Colney Heath Group (CH Group)

Appeal by Brett Aggregates Limited

Land at former Hatfield Aerodrome Hatfield Hertfordshire AL4 0JB

Proof of Evidence - Public Access

Graph 1 - Route 1 Assessment - Albatross Way to Smallford

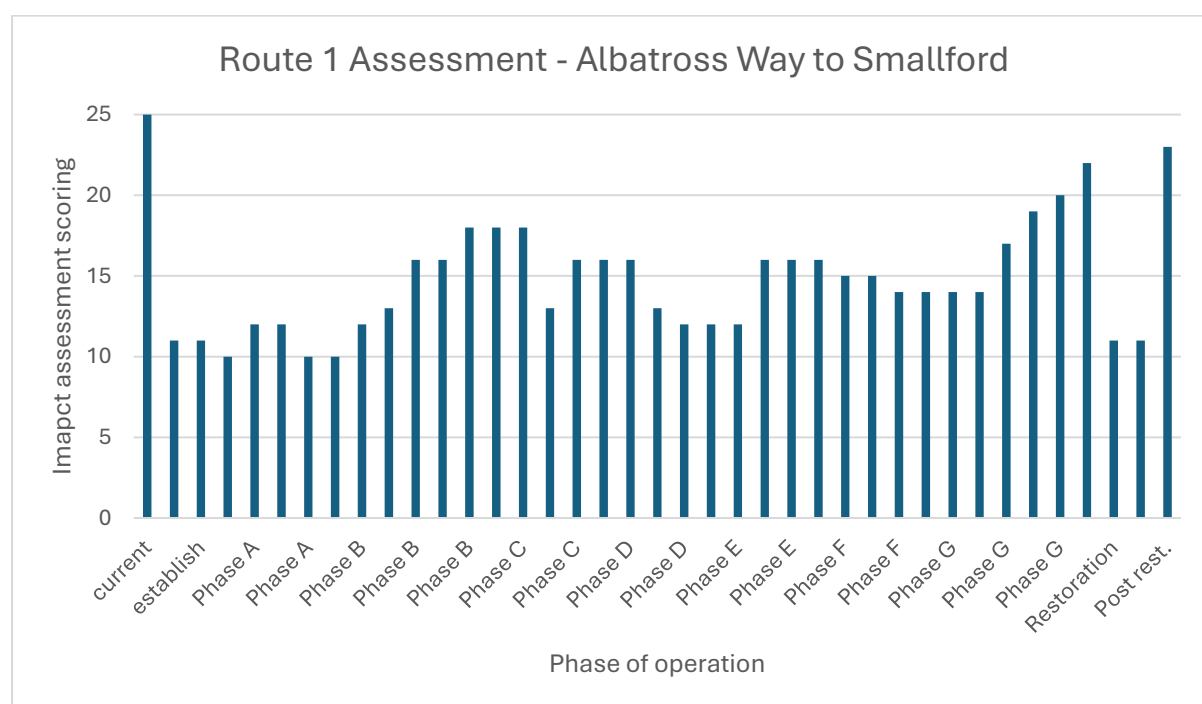
2.33 Graph 1 below plots the Route 1 impact assessment score for each stage in the phase (based on the detailed analysis). A low score correlates to an increased negative impact on the users of the park.

2.34 For users of Ellenbrook Fields, the current position (ie no quarrying) Route 1 impact assessment score is 25. During establishment this score falls significantly to 11. It remains low during phase A with a trough of 10, then rises and falls during subsequent phases, with a peak of 22 during phase G, after which during the restoration phase it drops significantly to a score of 11.

2.35 **The establishment and restoration scores are a drop of 14 from the current (no quarry) score of 25. Phase A troughs are a drop of 15.**

Graph 2 - Route 2 Assessment - Hatfield Barlow entrance, around Round Wood to Smallford

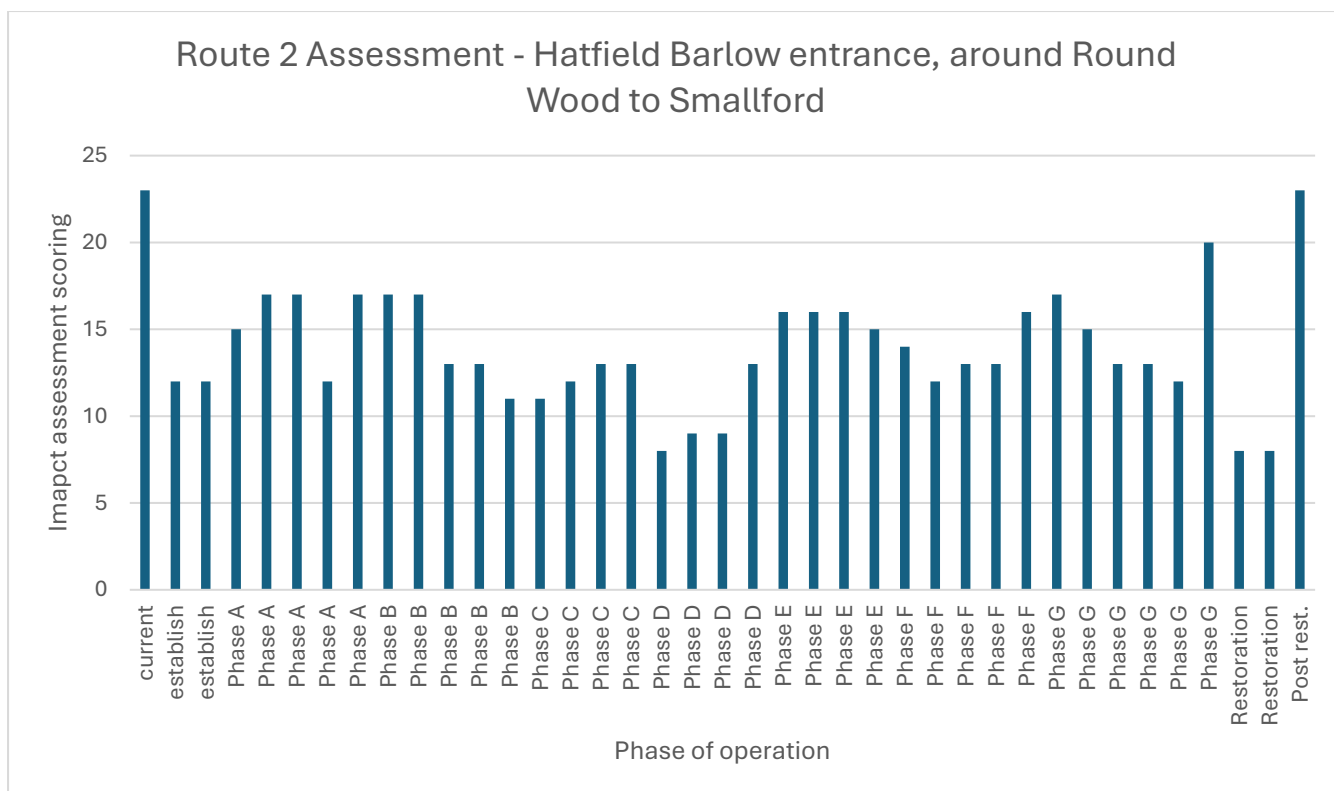
- 2.38 Graph 2 below plots the Route 2 impact assessment score for each stage in the phase (based on the detailed analysis). A low score correlates to an increased negative impact on the users of the park.

- 2.39 For users of Ellenbrook Fields, the current position (ie no quarrying) Route 2 impact assessment score is 23. During establishment this score falls significantly to 12. It then rises and falls during subsequent phases, with a very low score of 8 in phase D, then improves with a peak of 20 during the last stage of phase G. After which during the restoration phase it drops to significantly again to a very low score of 8.

- 2.40 The restoration score of 8, and the trough in phase D, are drops of 15 from the current (no quarry) score of 23.**
